BAW-10169-A  
Topical Report  
October 1989

- RSG PLANT SAFETY ANALYSIS -  
B&W Safety Analysis Methodology for  
Recirculating Steam Generator Plants

SUBJECT: ACCEPTANCE FOR REFERENCING OF LICENSING TOPICAL REPORT,  
BAW-10169P, "RSG PLANT SAFETY ANALYSIS"

### SAFETY EVALUATION OF THE BABCOCK & WILCOX COMPANY TOPICAL REPORT BAW-10169, RSG PLANT SAFETY ANALYSIS

Figure 6.2. Babcock & Wilcox RSG Plant Steam Line Break (Low Power) Model

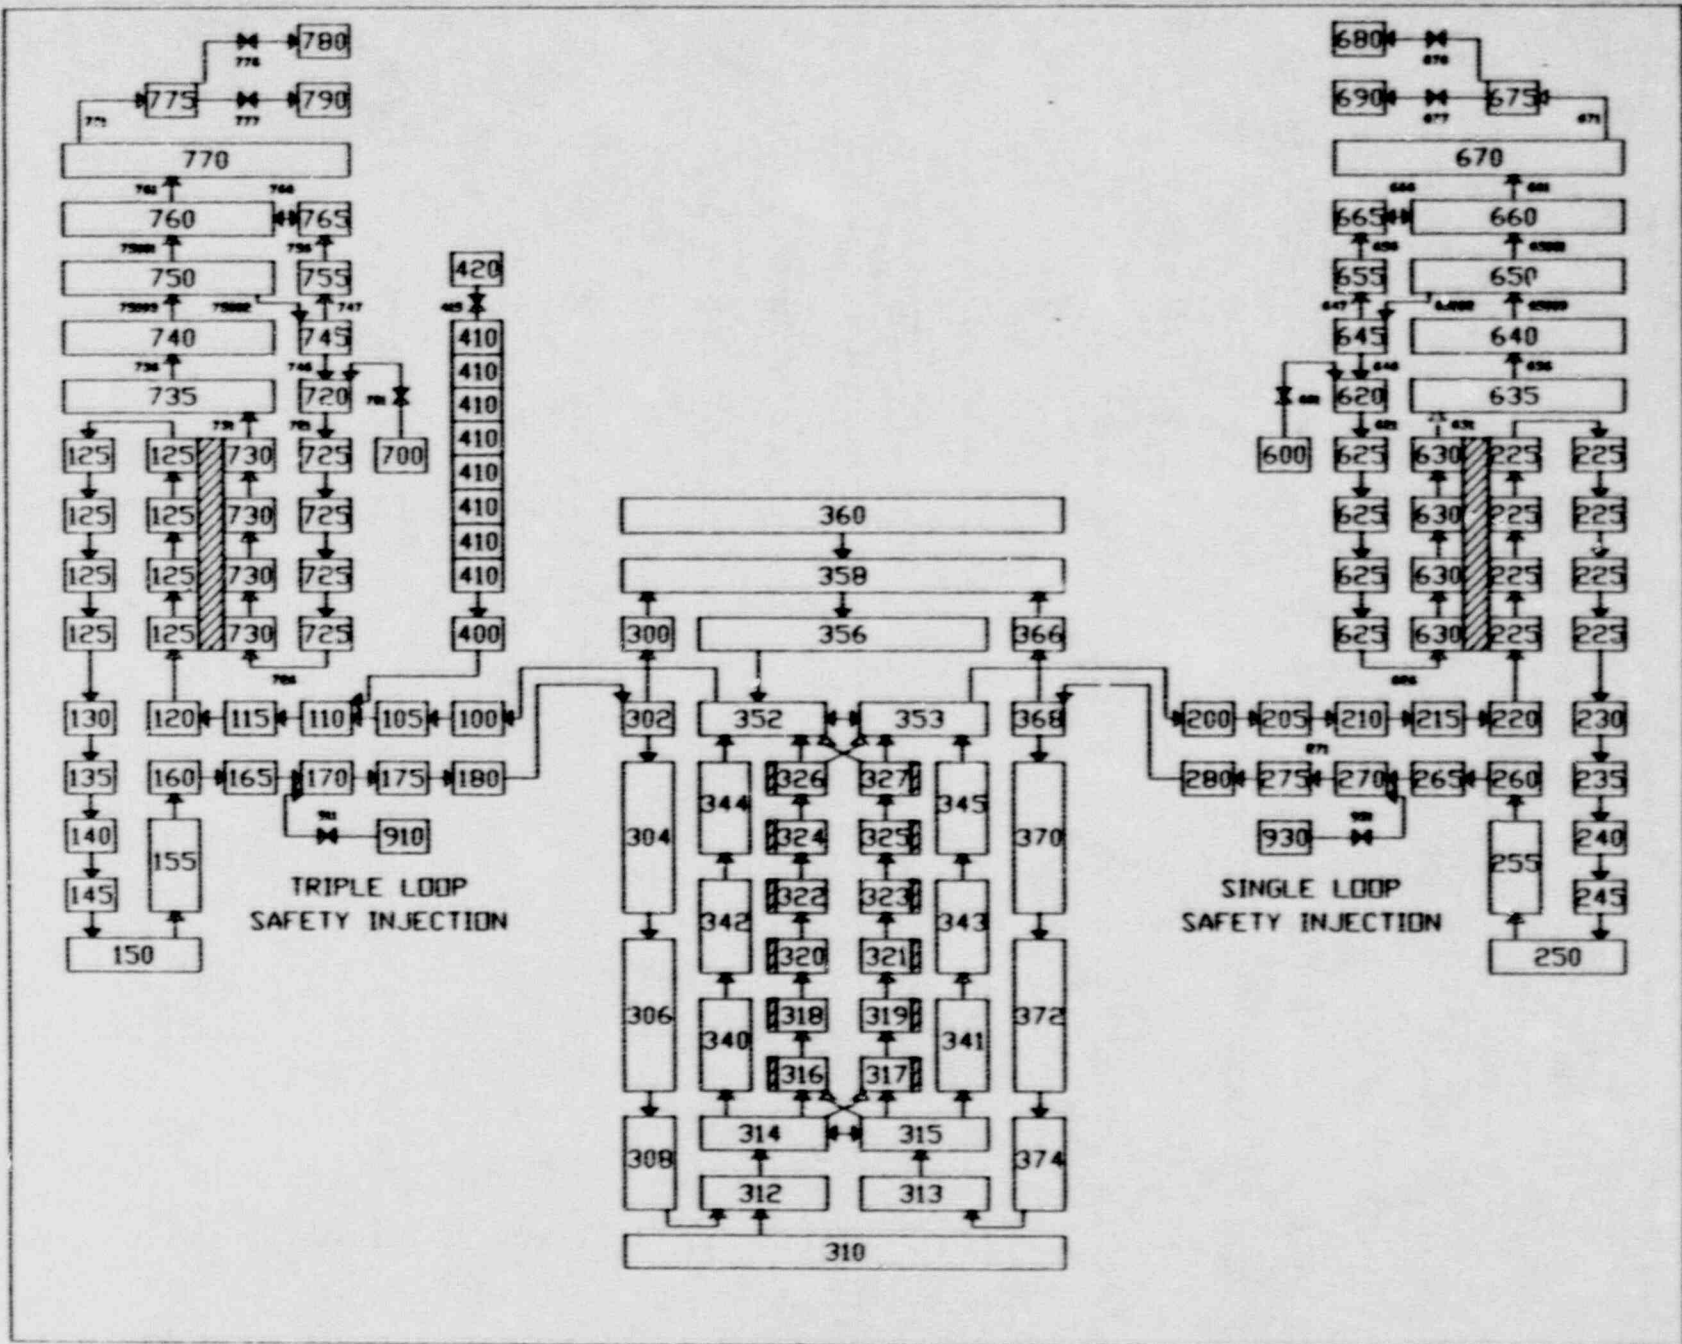
In the RSG steamline break (low power) model (Figure 6.2), crossflow paths (Junctions connecting nodes 315 and 316, 314 and 317, 327 and 352, and 326 and 353) are provided at the core inlet and outlet to allow for flow mixing between the broken loop and the single intact loop. Since the reactivity feedback is determined by the single (broken) loop coolant density, the crossflow mixing is an important parameter in determining the reactivity and return to power.
